Cessnock Correctional Centre
Residential Accommodation and Associated Facility
Upgrades

On behalf of Corrective Services NSW, a Division of the
Department of Justice

28 August 2018 | 218624

This Addendum Review of Environmental Factors (Addendum REF) has been prepared for Corrective Services NSW, a Division of the Department of Justice (NSW Justice) to assess the potential environmental impacts that could arise from the expansion works of the existing Cessnock Correctional Centre.

Figure 10 Proposed General Arrangement

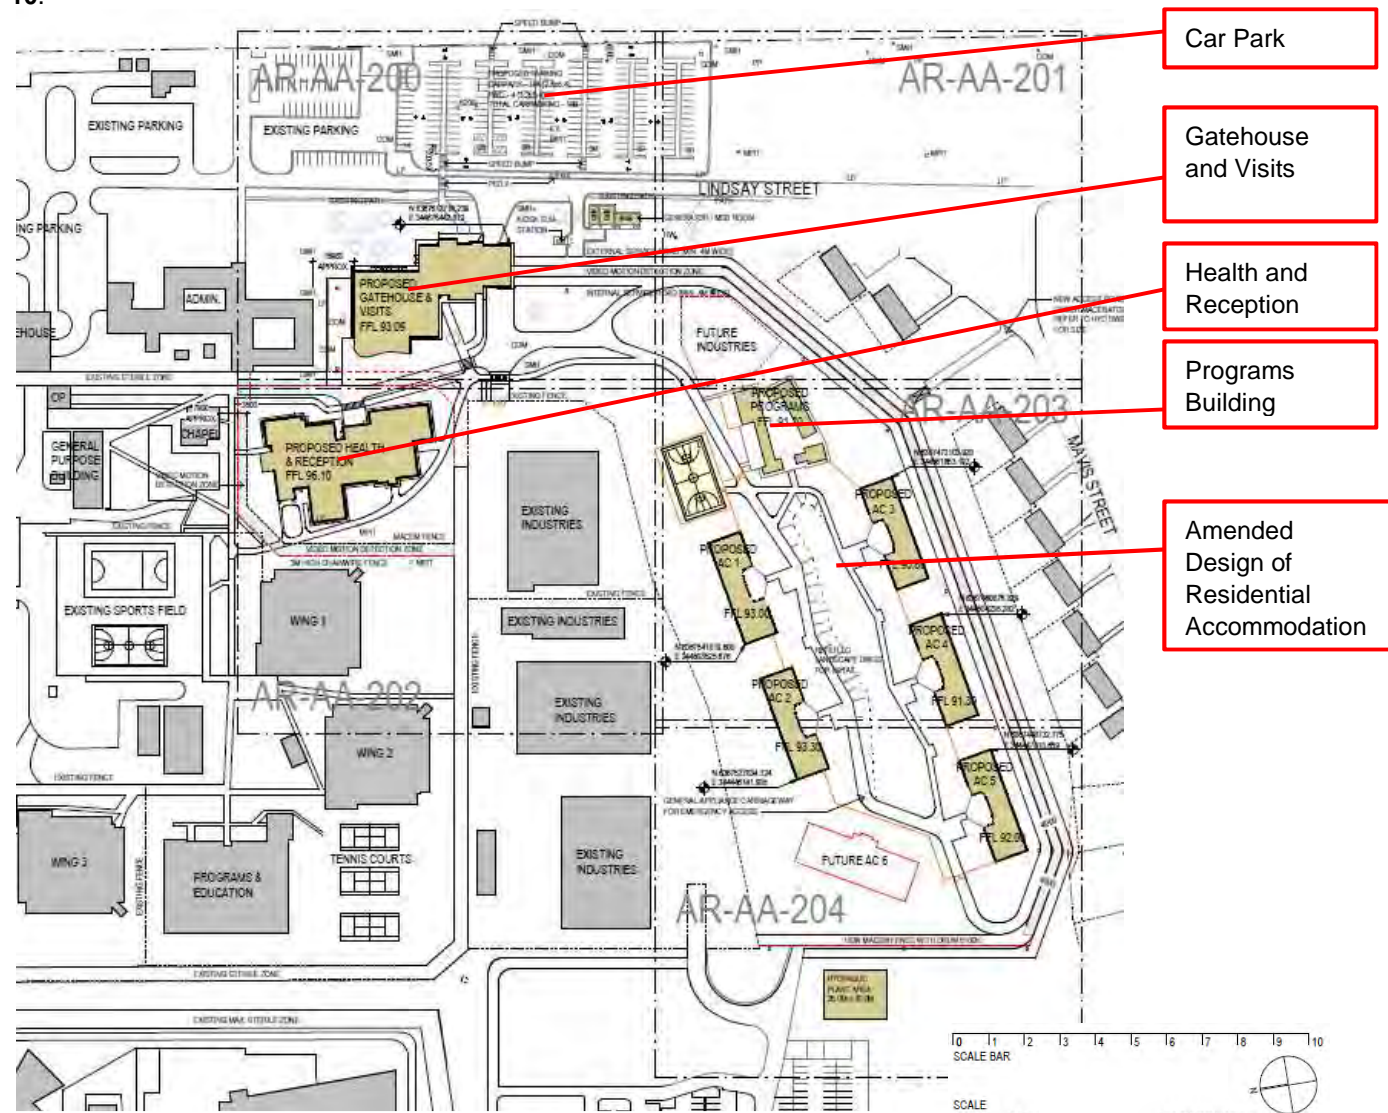
This REF seeks to amend the approved scope of works to integrate the residential accommodation to the existing security facility and incorporate a relocated gatehouse, health and reception centre, programs building, linking facilities and car park. The proposed changes and additional activity are detailed in the Architectural Plans at **Appendix A**.

The arrangement proposed by the addendum is shown at the Site Plan at **Appendix A** and reproduced at **Figure 10**.

Original REF location	Addendum REF location
Gatehouse and Visits Building	West of the residential accommodation area	Adjacent to Lindsay Street
Health and Reception Building	West of the residential accommodation area	Within the existing CCC facility
Programs Building	West of the residential accommodation area	East of the residential accommodation area
Car Park	West of the residential accommodation area	East of Lindsay Street

Figure 11 Location of Temporary Visits Structure

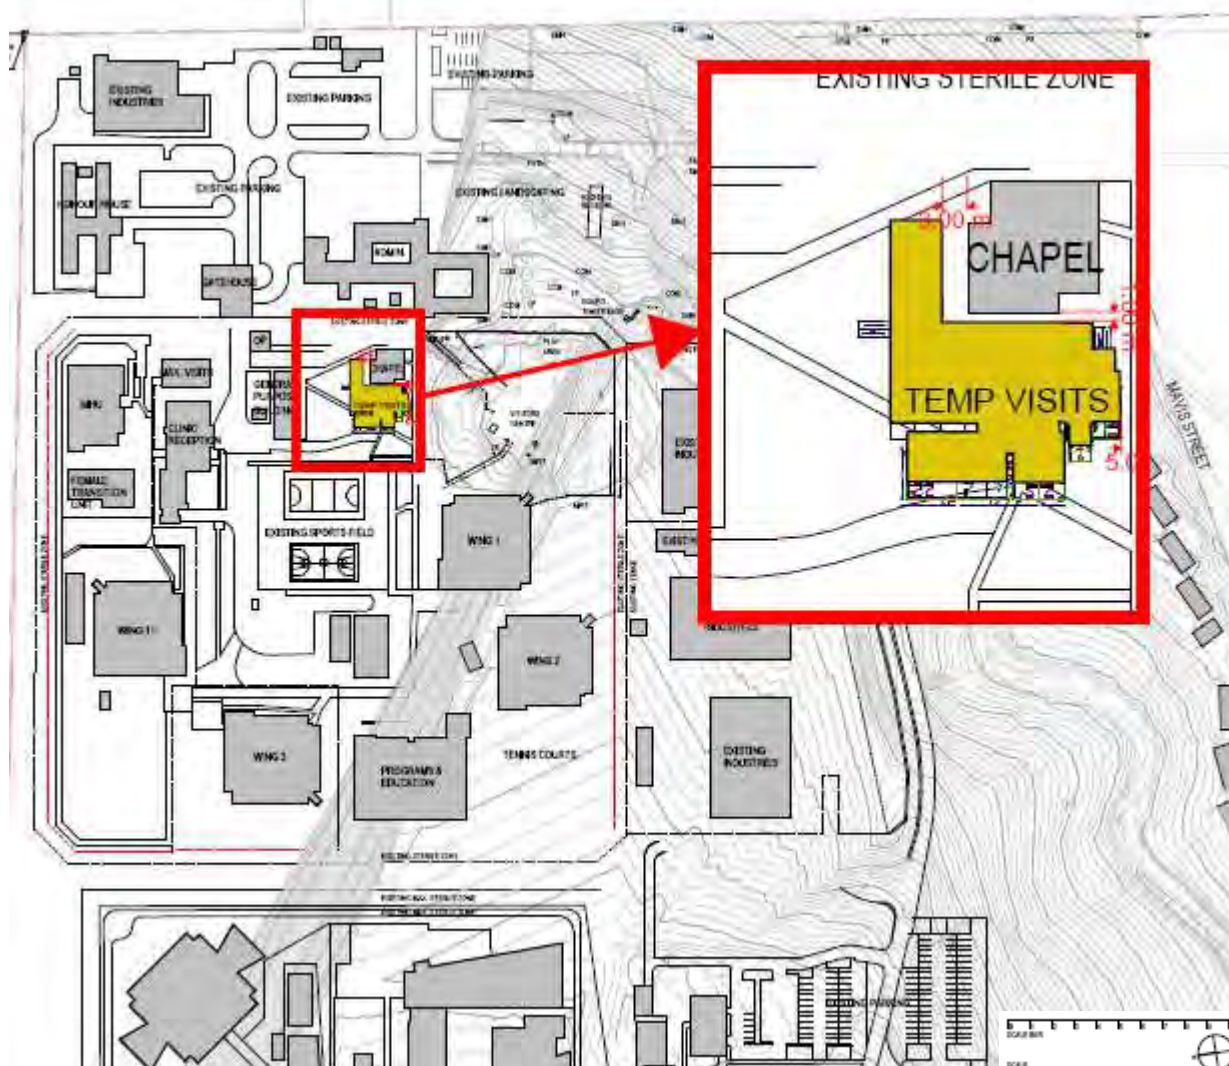
A temporary Visits Building and associated security fencing is proposed to be delivered as an interim measure until the permanent Visits building is operational, at which point the structure will be removed.

Figure 12 On-site detention basin plan

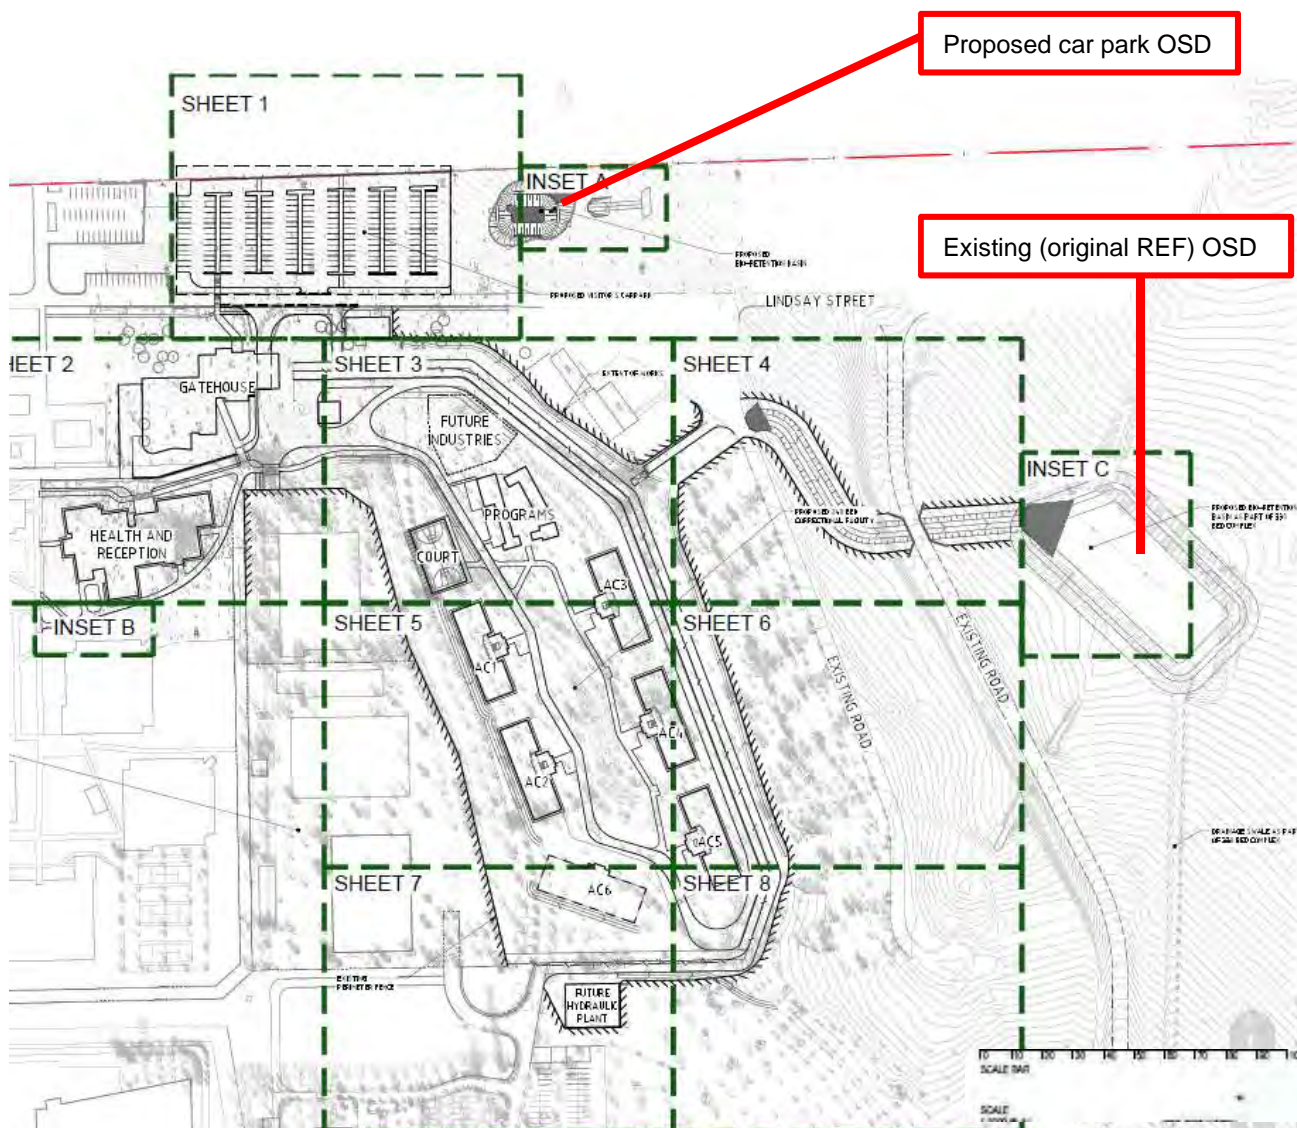
The relocated car park will drain via an in-ground drainage network to an additional OSD basin that has been designed to restrict flow rates exiting the site. The location of OSD is shown at **Figure 11**.

Northrop confirm the inground drainage network is capable of conveying the 1 in 20 year (5% AEP) storm event, with the allowance for overland flow paths in storm events greater than the 1 in 20 year event.
